# ASSESSMENT REPORT

## Moolarben Coal Mine Section 75W Modification (MP 05\_0117 MOD 6)

Figure 3: Proposed Rejects Bin Location

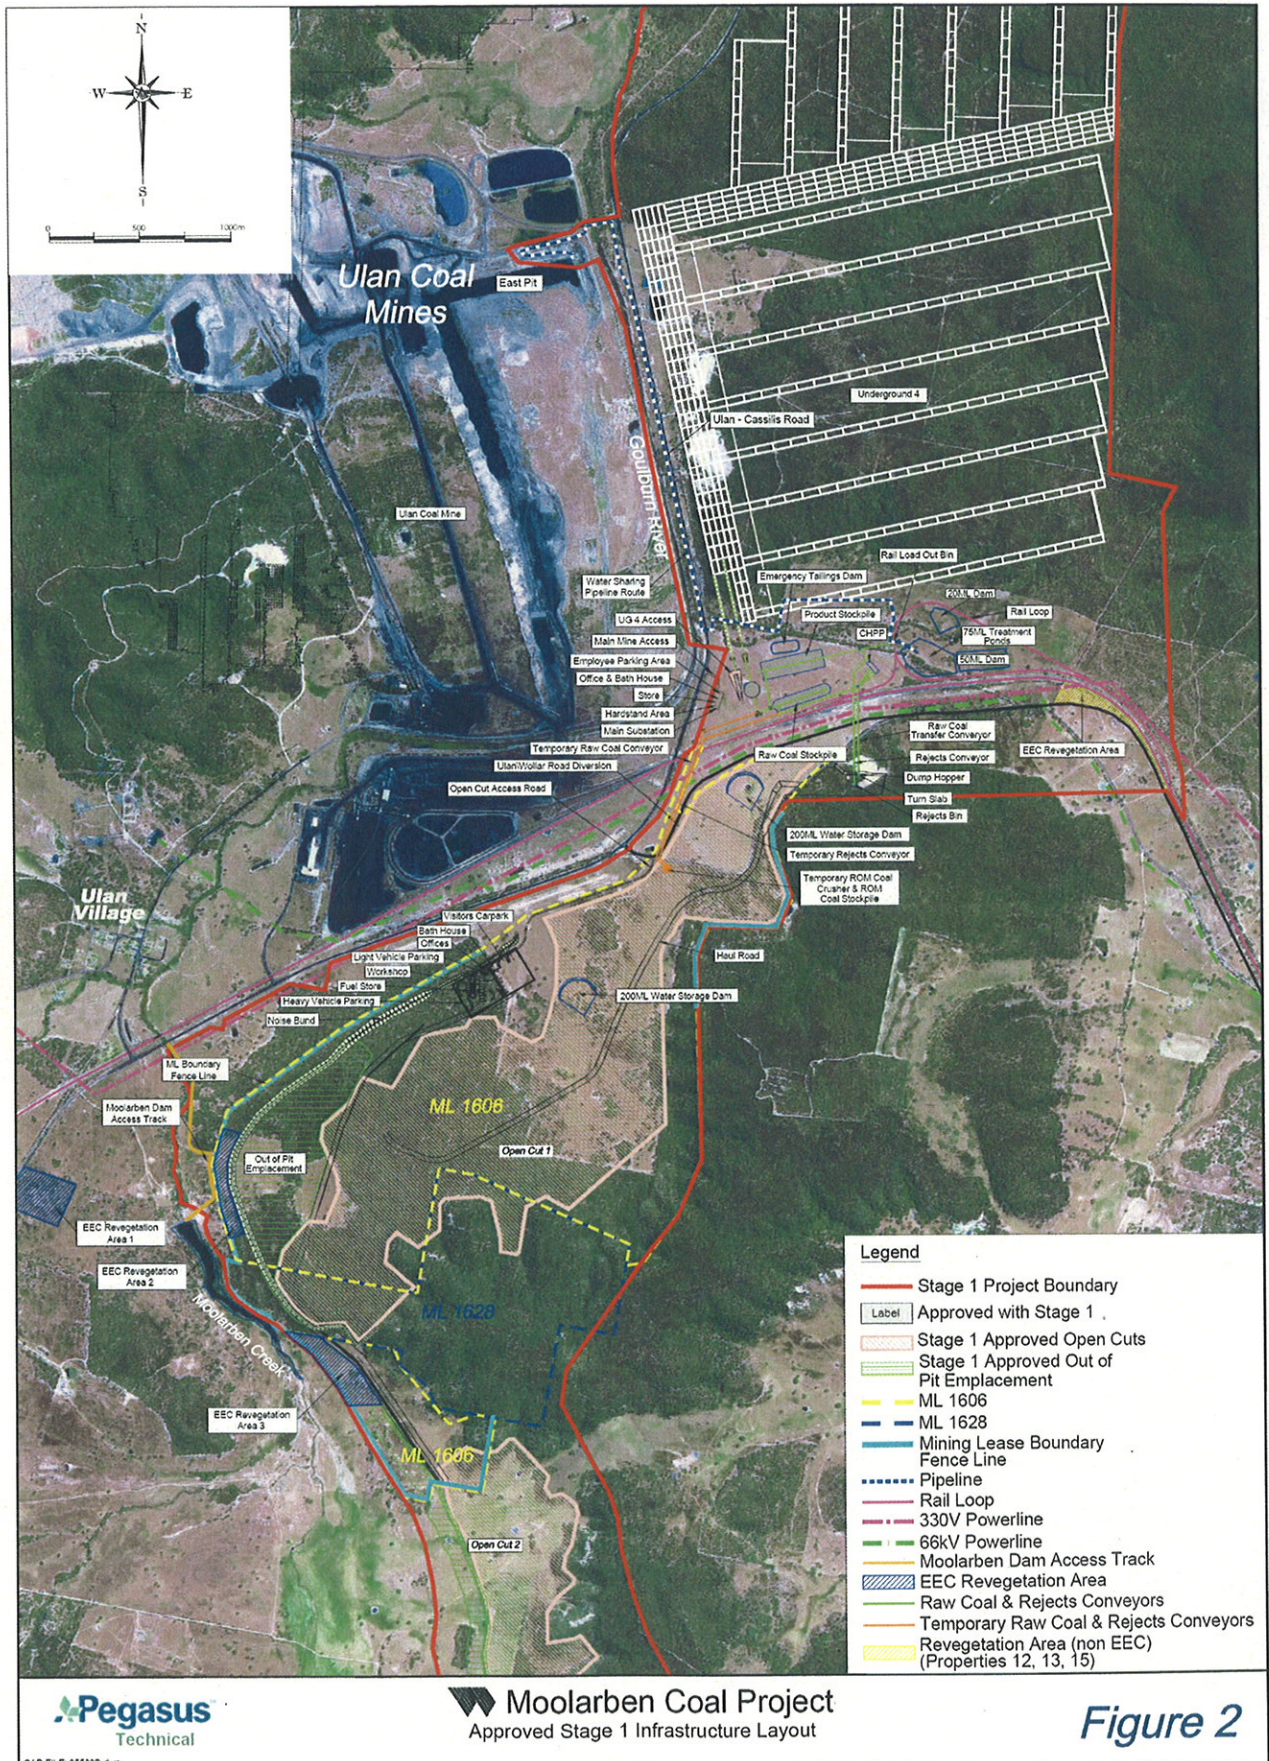
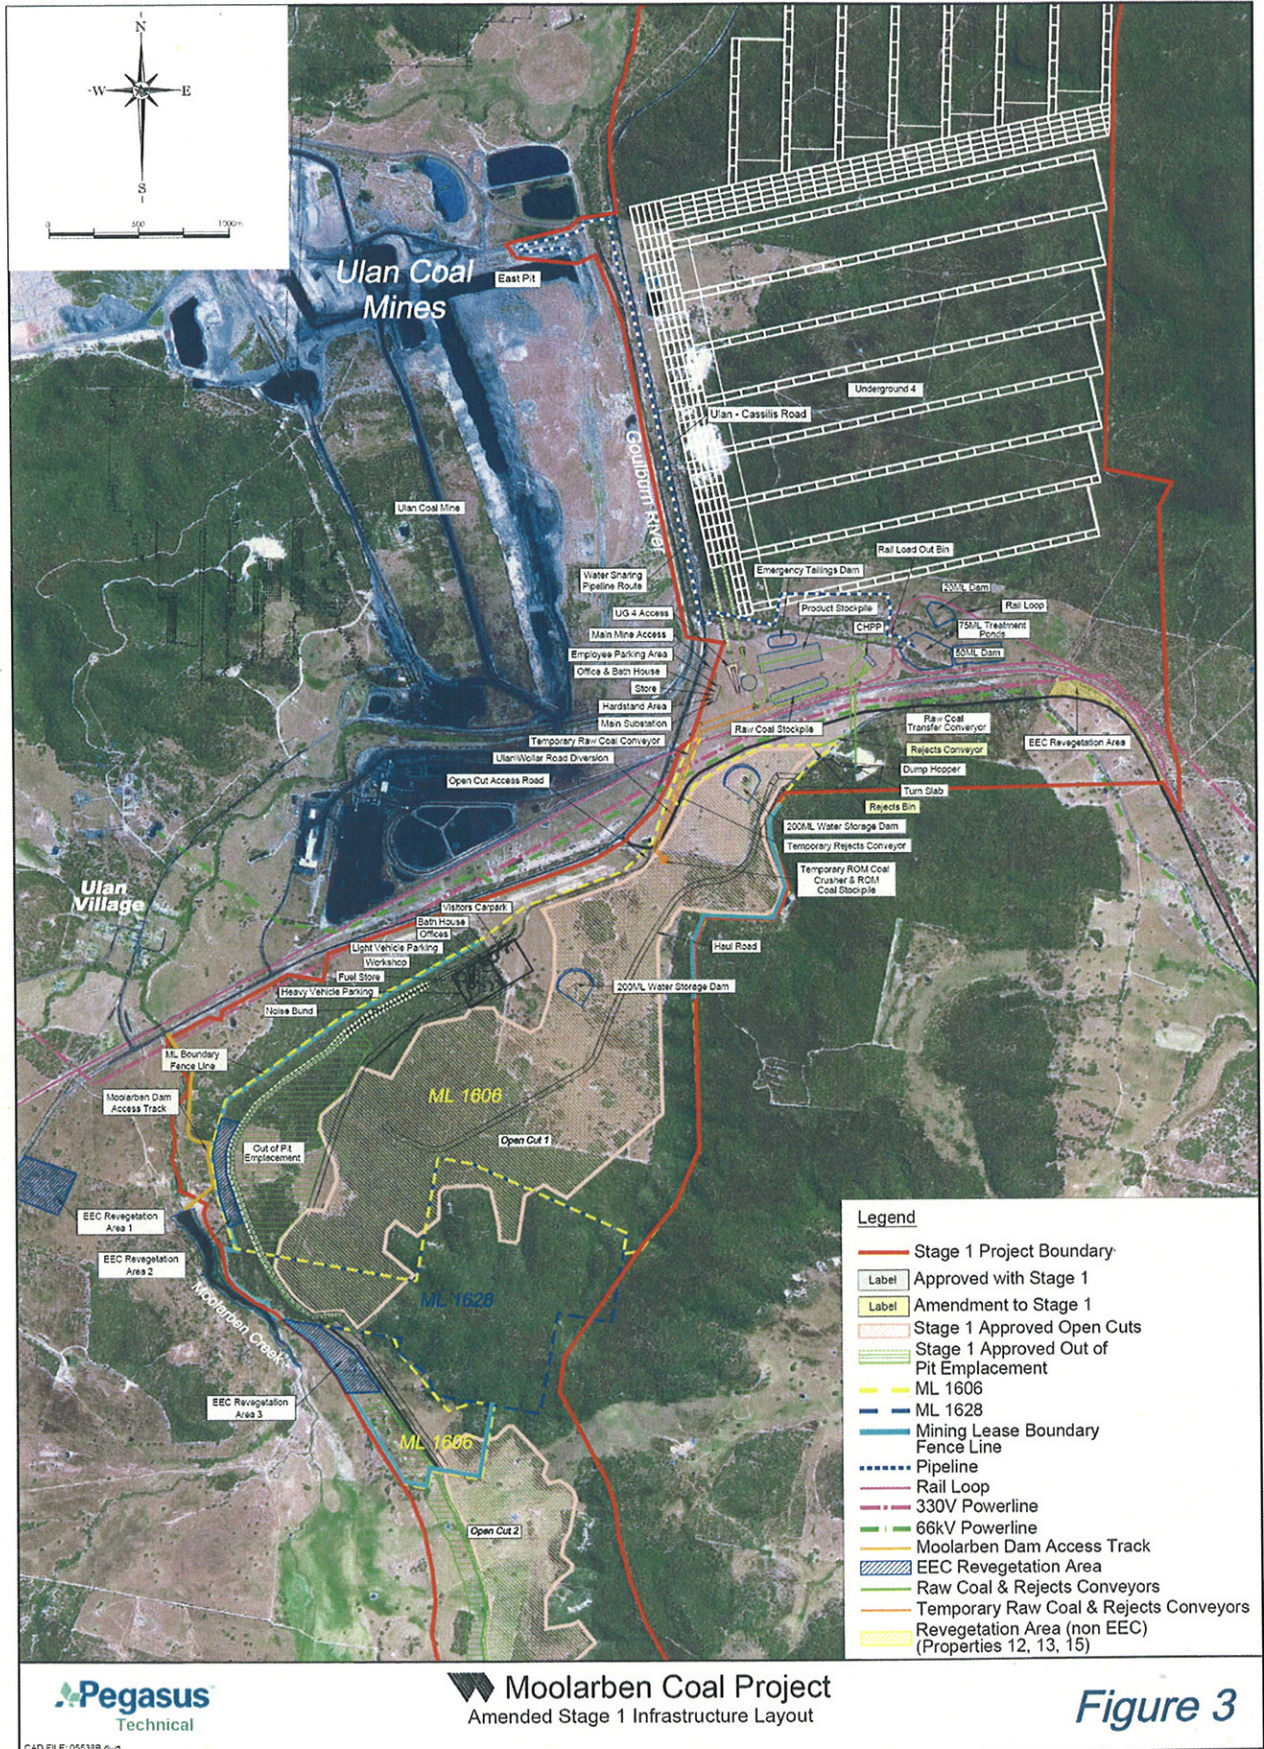
The proposed modification seeks approval to relocate the coal rejects bin (which is yet to be constructed) 250 metres northwest of its approved location and double its capacity from 250 tonnes (t) to 500 t (see Figures 2 & 3). The proposal would increase the approved height by 5 m to a maximum of 30 m, and would increase the disturbance footprint of the rejects bin from approximately 20 m<sup>2</sup> to approximately 25 m<sup>2</sup>. The proposed location would be on cleared grazing land adjacent to the northeastern extent of a proposed open cut pit (OC1). Coal rejects (a by-product of the coal washing process) would be transferred from the coal washery via a conveyor to the rejects bin, where they would be temporarily stored prior to being transported via truck to be emplaced within the OC1 void.

The proposed modification would improve haul truck access to the rejects bin, which would allow more efficient handling of coarse rejects and tailings from the washing of Stage 1 coal. The proposed increase in capacity to 500 t would ensure sufficient capacity for future handling of increased reject should the Stage 2 expansion be approved.
